Haverstock Hill/ Rosslyn Hill Walking, Cycling and Road Safety Scheme Consultation Permanent Proposals

This response to the consultation on the above proposal from Camden Council is from Camden Cycling Campaign, the local borough group of London Cycling Campaign. We represent the interests of cyclists living or working in or travelling through Camden and aim to expand the opportunities for all to cycle safely in the borough. We discussed this consultation in detail at our May meeting and also in email.

Figure 3. Junction at Howitt Road – from Drawing 6

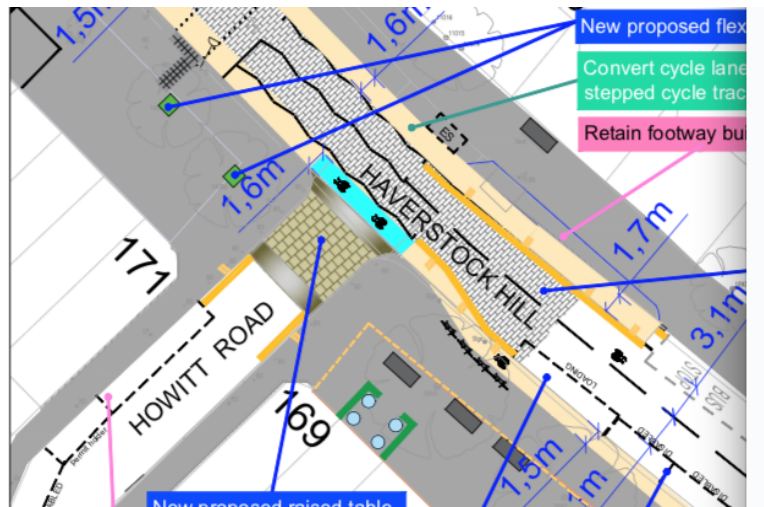
We are concerned about the safety of northbound cyclists passing Howitt Road (Figure 3). They are at risk of being cut up by overtaking vehicles as the cycle track moves out from behind the floating parking into a potential pinch point. They would be better protected with the design shown in Figure 2.

Figure 4: the Old Town Hall and past Belsize Avenue – from Drawing 8

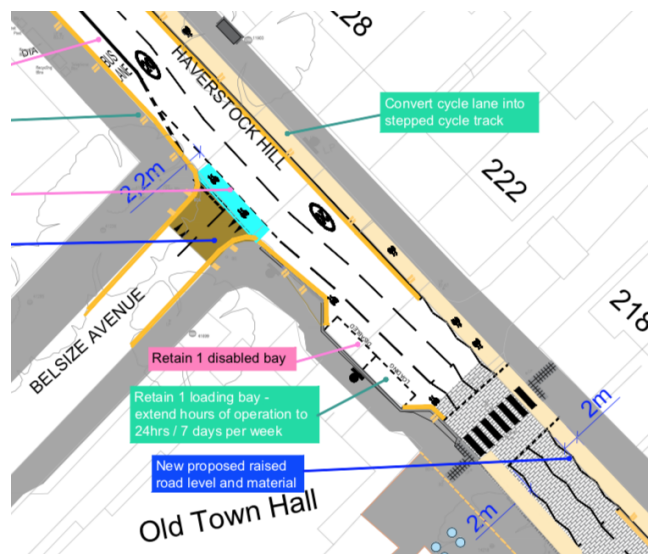
See Figure 4. We would like to see a stepped track northbound from the zebra crossing and continuing across Belsize Avenue as shown in Figure 2, then dropping down to meet the shared bus lane.

The inset loading and parking bays outside the Old Town Hall would need to be at the same level as the stepped track.
